Re: Register Ref. SD21A/0327
Request for Additional Information
Location: Site at Gordon Park, Old Naas Road, Kingswood, Dublin 22
Applicant: Greenwalk Development Ltd.

We refer to the request for additional information on Planning Submission Reg. Ref. SD21A/0327. We enclose the following documents and drawings as part of the response to this request for Additional Information.

Figure 2 – Layout of Petrol/Oil Separator

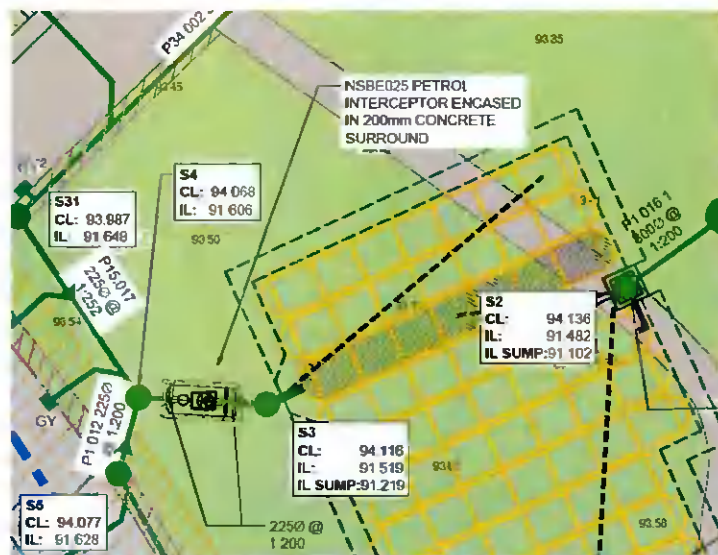
Item 8 (c) The applicant is requested to clarify and illustrate on a drawing if a petrol interceptor is proposed prior to entry of surface water to arched type proposed attenuation systems. A suitable sized petrol/oil interceptor should be proposed.

A petrol/oil interceptor was shown on Drg 21003-TJOC-ZZ-ZZ-DR-C-0065 which was included in the original planning submission. This drawing has been updated as set out above and the revised drawing is included in the response to the Additional Information request. An extract from the drawing is enclosed below for reference also. A Klargestor NSBE025 Petrol/Oil interceptor is proposed to be installed at the upstream end of the arched type attenuation system. The interceptor has been sized based on the contributing surface area of the site and the flow rate in the surface water system.

Figure 3 – Location of Surface Water Flow Control Device

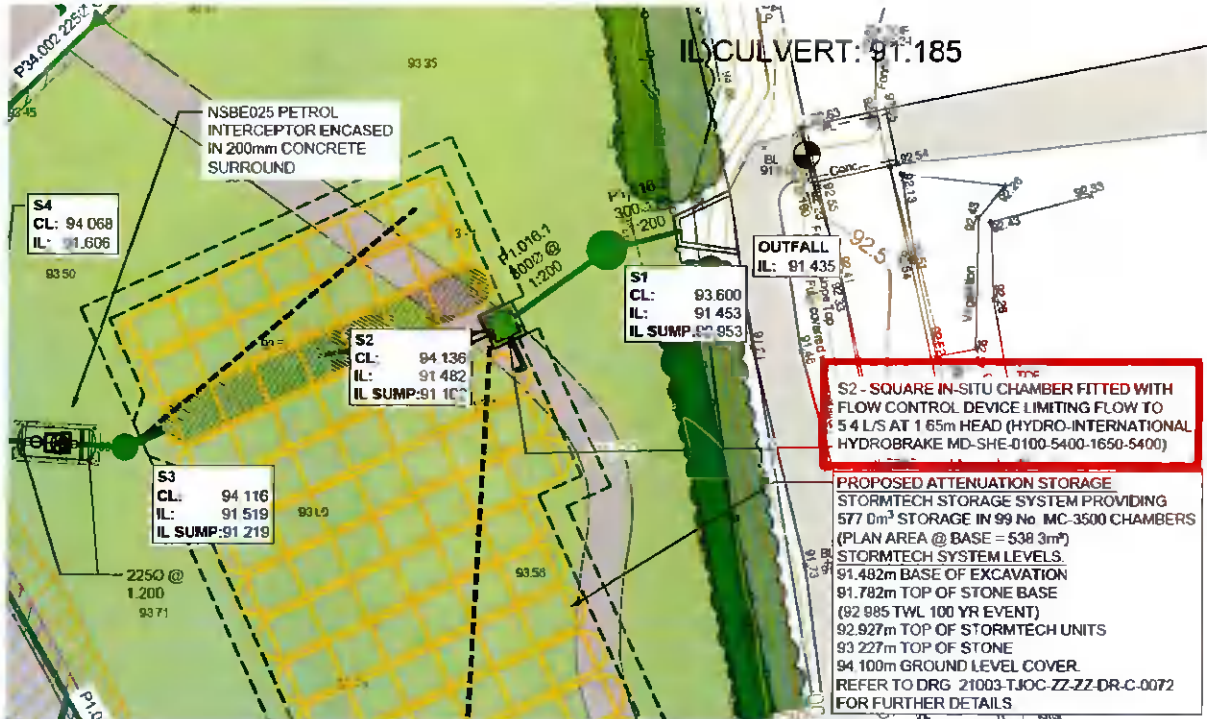
Item 8 (d) Water Services of SDCC estimate that surface water discharge should be limited to 5.1 litres/ second and not 6.5 litres/second as proposed on drawing number 21003-TJOC-ZZ-DR-C-0065. The applicant is requested to submit a report and drawing to explain this difference and adjust where necessary.

A flow control device with a surface water discharge rate of 5.4 l/sec was shown on Drg 21003-TJOC-ZZ-ZZ-DR-C-0065 which was included in the original planning submission. A second flow control device was also indicated on this drawing. The purpose of the second flow control device was to hold back and control surface water flow in the surface water network within the site. The limit set for the second flow control device is 6.5l/sec. However, there is only one surface water discharge point from the site and the flow control device at this point is set at 5.4l/sec.

The discharge rate of 5.4l/sec was determined using the HR Wallingford Greenfield run-off rate calculator. This calculation was included in the Engineering services report in the original planning submission and is appended to this letter also. The site parameters used to determine the greenfield run-off rate are set out overleaf.

We refer to the extract below which shows the location of the flow control device that limits the surface water discharge from the site to 5.4l/sec.
